EWP G1 External work platform – FAT documentation	25220 Hollandse Kust Zuid
---	--	---

Mechanical Release Note EWP Rev 2 #19

Punchlist mechanical

Punchlist Final Release Coating		SMU-RN-PL
Project ID		25220		
Project Name		Holland Kust Zuid (HKZ)		
Item	Name	External Work Platform		
	EWP N°	HZG1 - EWP17		
Date		29.06.2021		
Location		Smulders Projects Belgium

● #1382 - Sharp edges

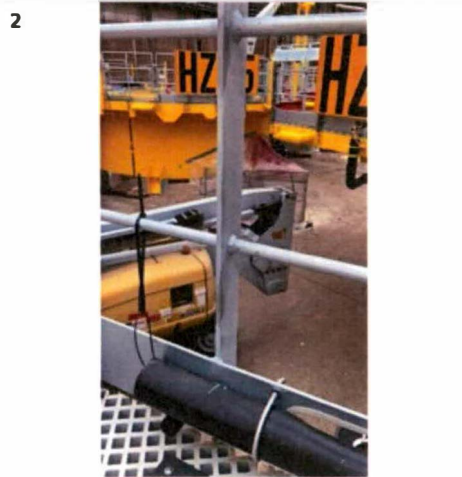
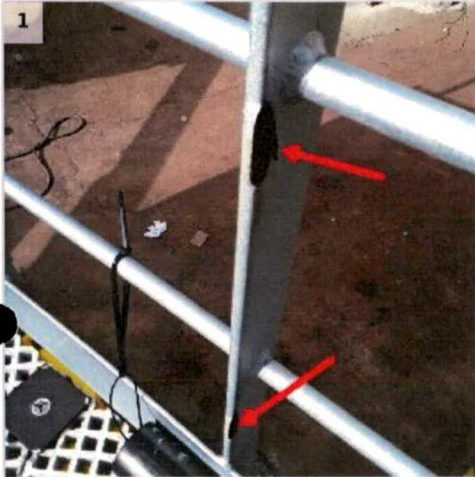
Ben Herygers Photo 1
Ben Herygers Sharp edges @Mechanical @kevin_kempis #client
Jens Daelemans Photo 2

● #1400 - To big gap on the finger guide

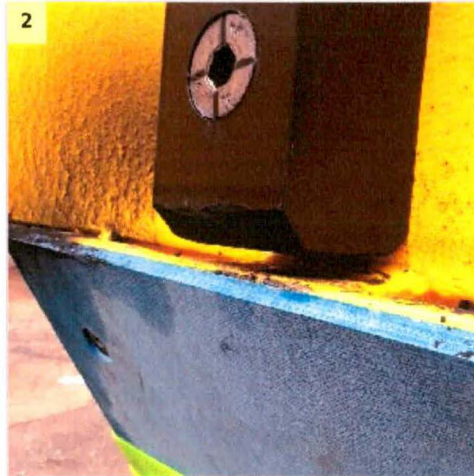
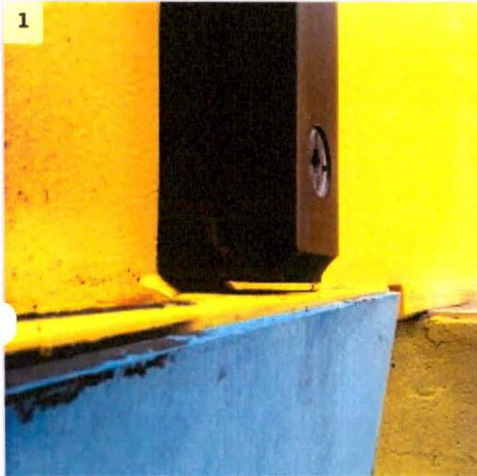
Ben Herygers	Photo 1	26 Jun 08:06
Ben Herygers	Photo 2	26 Jun 08:07
Ben Herygers	To big gap on the finger guide @Mechanical #client @kevin_kemps	26 Jun 08:07

● #1401 - Needs better chamfer

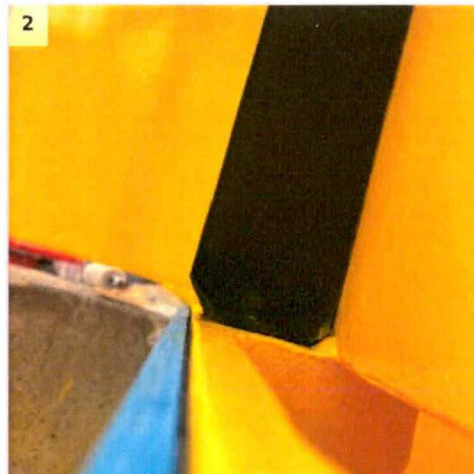
Ben Herygers	Photo 1	26 Jun 08:07
Ben Herygers	Needs better chamfer @Mechanical @kevin_kemps #client	26 Jun 08:08
Marcin Witkowski	Photo 2	29 Jun 13:31

● #1402 - Plate needs more adjustment (better in the middle)

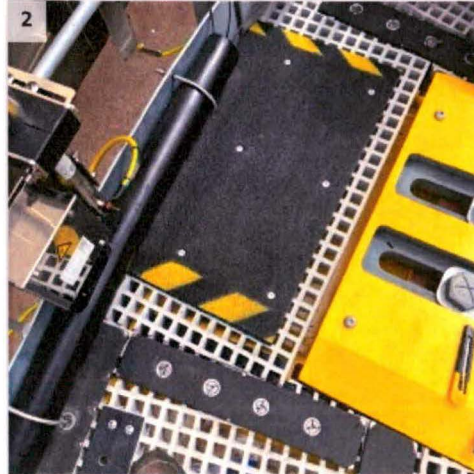
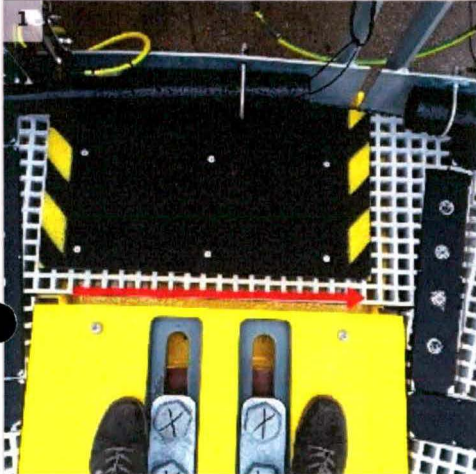
Ben Herygers	Photo 1	26 Jun 08:15
Ben Herygers	Plate needs more adjustment (better in the middle) @Mechanical @kevin_kemps #client	26 Jun 08:16
Marcin Witkowski	Photo 2	29 Jun 12:05

● #1403 - Coating missing

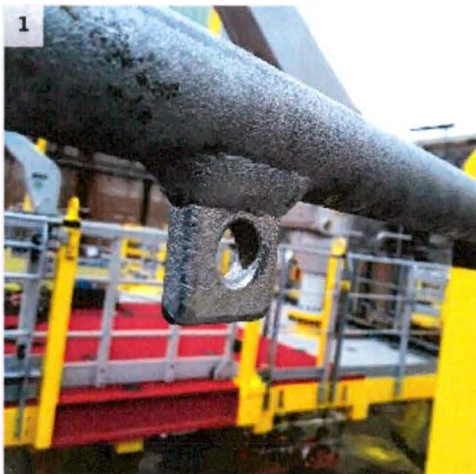
Ben Herygers	Photo 1	26 Jun 08:25
Ben Herygers	Photo 2	26 Jun 08:25
Ben Herygers	Photo 3	26 Jun 08:25
Ben Herygers	Coating missing @TouchUp @ilchan_chanko #client	26 Jun 08:26
Ilchan Chanko	Photo 4	28 Jun 11:41
Ilchan Chanko	Photo 5	28 Jun 11:41

● **#1404 - Video missing for the double gate**

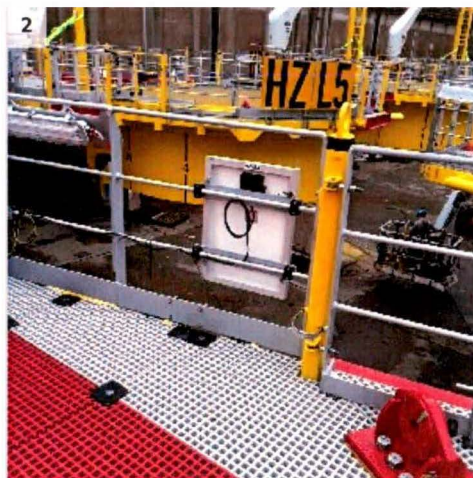
Ben Herygers	Photo 1	
Ben Herygers	Photo 2	
Ben Herygers	Video missing for the double gate @Mechanical @dawid_kaminski @kevin_kemps #client	
Ben Herygers	For opening from the gate	
Marcin Witkowski	Check task #1509

2.4 SS-Coated tie wraps are used

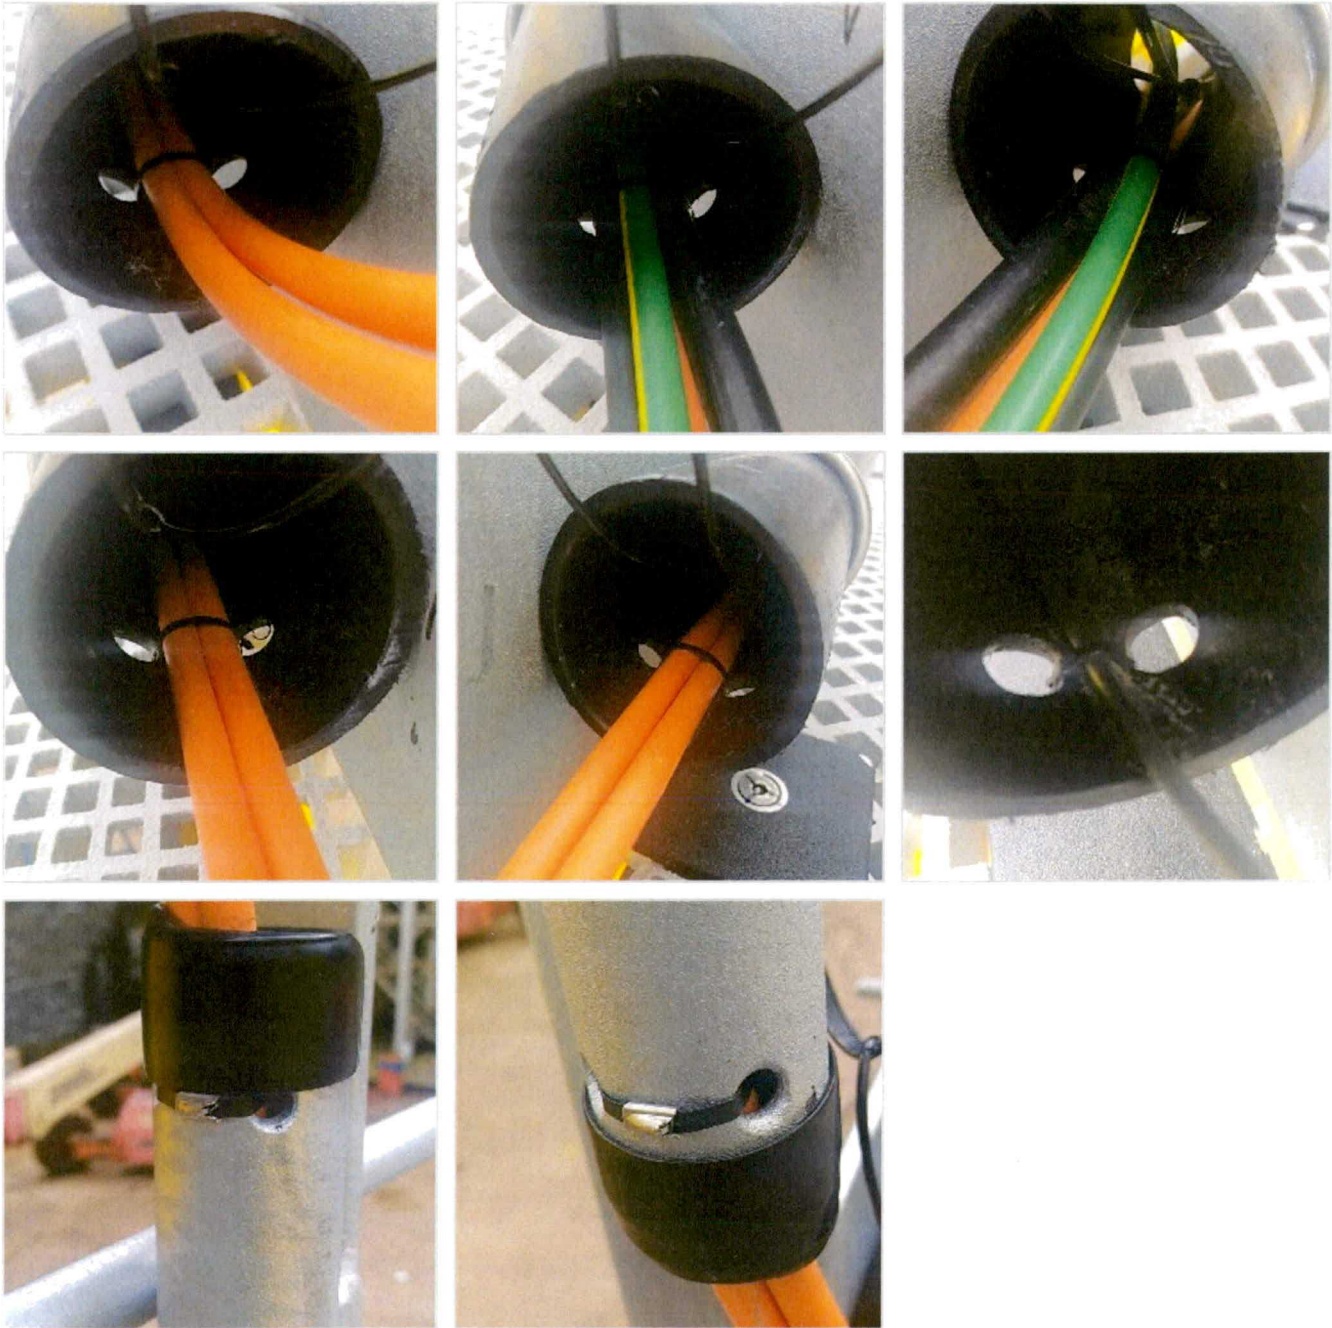
Remarks: Single cable from ID-Lights position 3, can be attached with plastic cable-ties.

H3M3		Rev. 2	Date: 29.06.2021

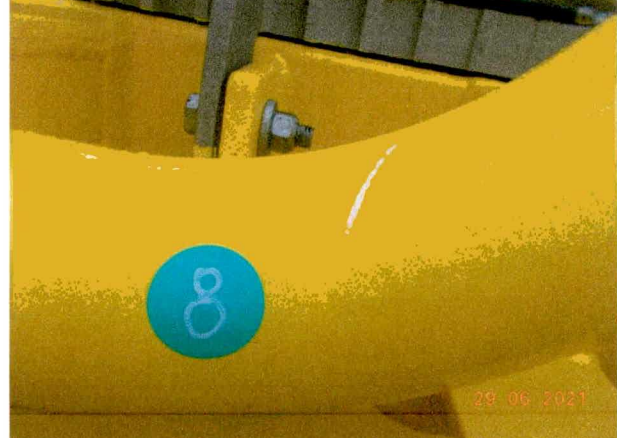
No. 7 – HDG railings, touch up rework required.		No. 8 – Fly rust and tape residue, cleaning required.

No. 9 – Mechanical damage to coating.		No. 10 – Full coat system must be applied 20 mm up face of plate. See drawing 8522.

No. 11 – Mechanical damage to coating.		No. 12 – Full coat system must be applied 20 mm up face of plate. See drawing 8522.

HZG1		Rev. 2	Date: 29.06.2021

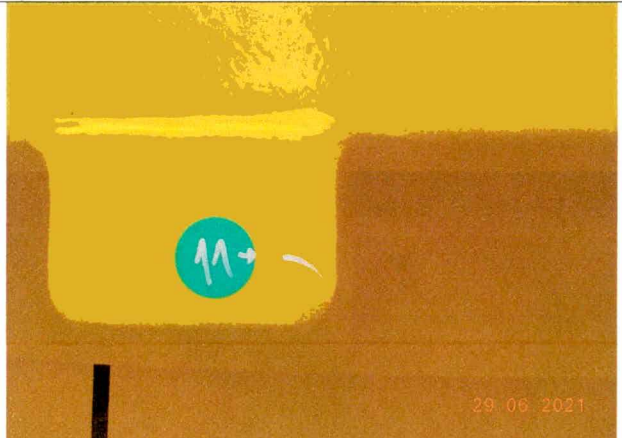
No. 1 – Fly rust and tape residue and dirt, cleaning required.		No. 2 – Touch up rework required.

No. 3 – Touch up rework required.		No. 4 - Touch up rework required.

No. 5 – Mechanical damages to coating.		No. 6 - Full coat system must be applied 20 mm up face of plate. See drawing 8522.
